1984 - 1990 Corvette: Service Bulletin: Service Part For Seat Cushion Retaining Wire

Number: 90-154-10

Subject: Service Part For Seat Cushion Retaining Wire

Model Year: 1984-1990 Y Car

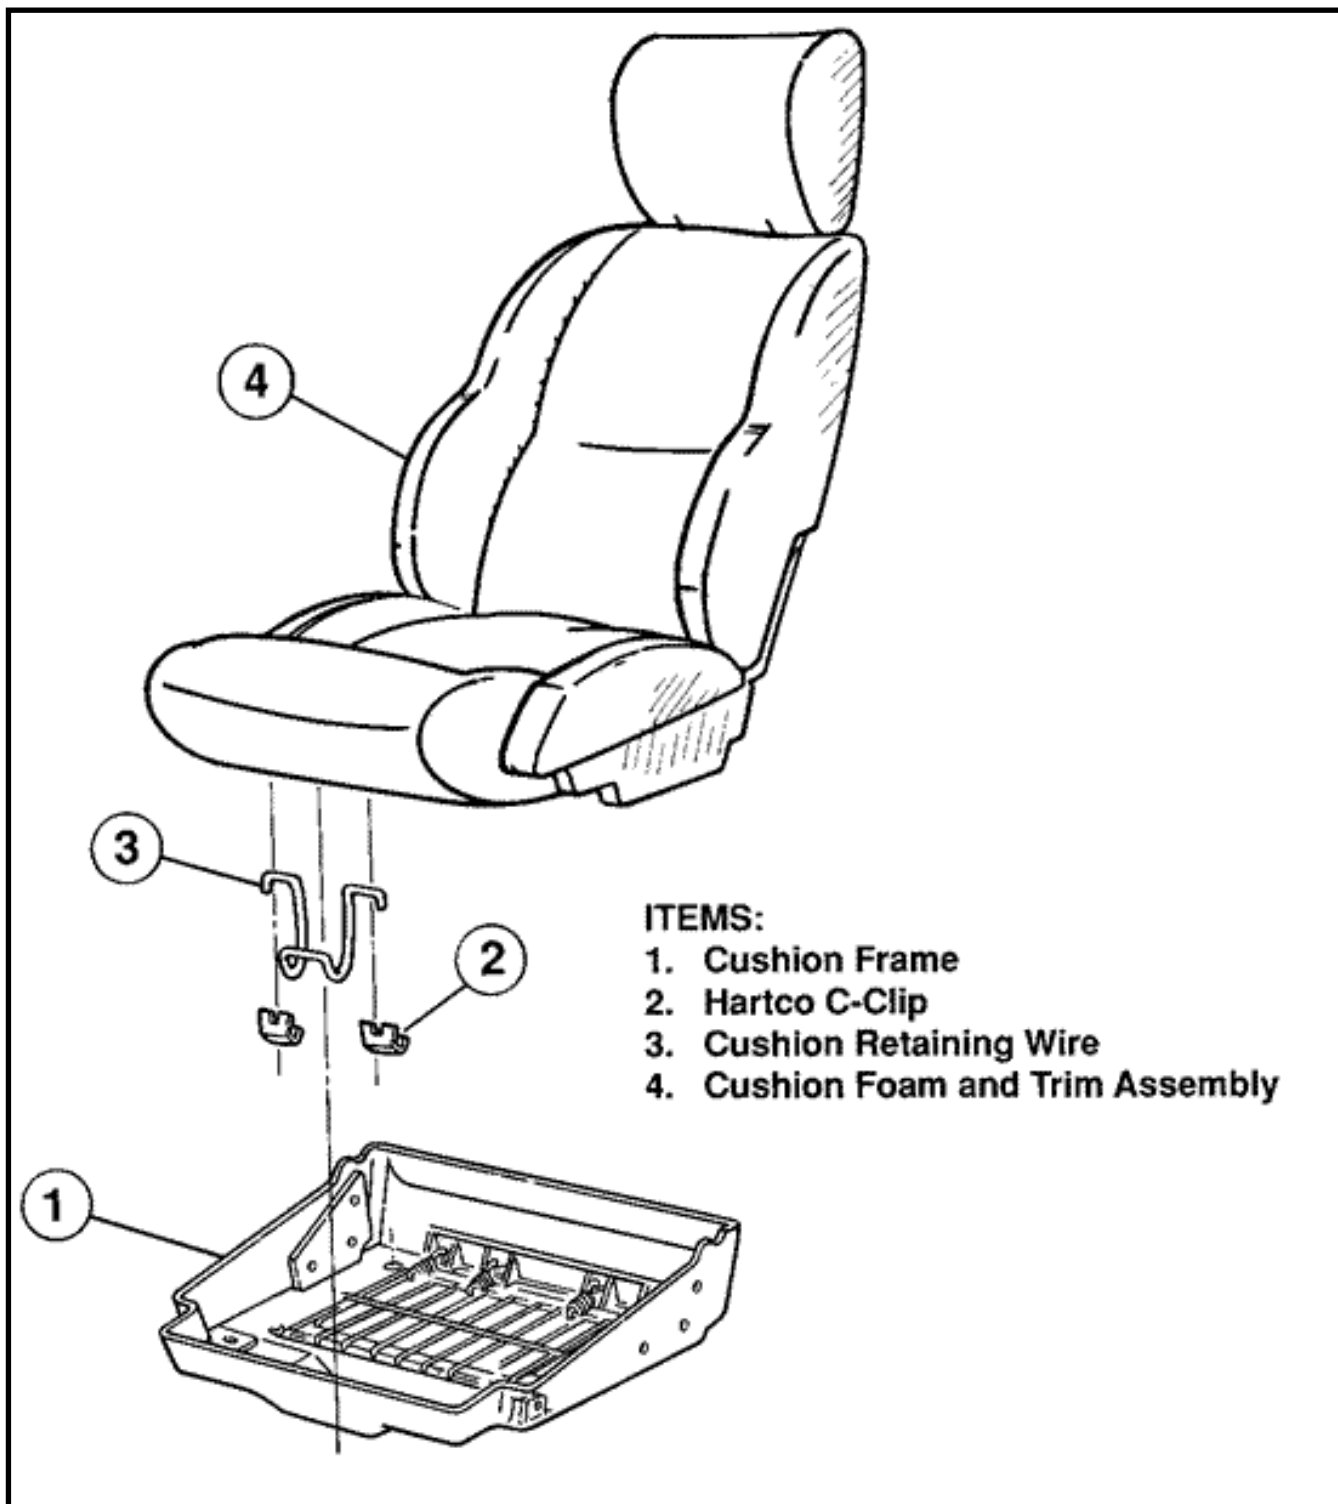
GMSPPO has released for service a cushion retainer wire service kit, P/N 10153686. On current and past model Corvettes, it was necessary to replace the seat cushion if the retaining wire broke. With the release of this kit simply replace the wire retainer as outlined below:

1. Remove cushion from frame by pushing down on top of cushion and unsnapping wire retainer.
2. Using side cutters remove Hartco C-clips from cushion border wire.

1. Position cushion retaining wire legs onto border wire extensions.

IMPORTANT: "J" shape of retaining wire must face toward front of vehicle.

2. Place Hartco clips around cushion retaining and foam cushion border wire. Both sides of clip should be visible. If necessary, pull foam slightly away from border wire.
3. With pliers, crush outer legs of Hartco clip around both cushion wire and legs of retaining wire. Then crush inner leg around wires. Clip should wrap securely around both wires.
4. Reinstall seat cushion to frame by putting cushion retaining wire through hole in frame then pushing down on top of cushion and snapping cushion retaining wire over frame projections.
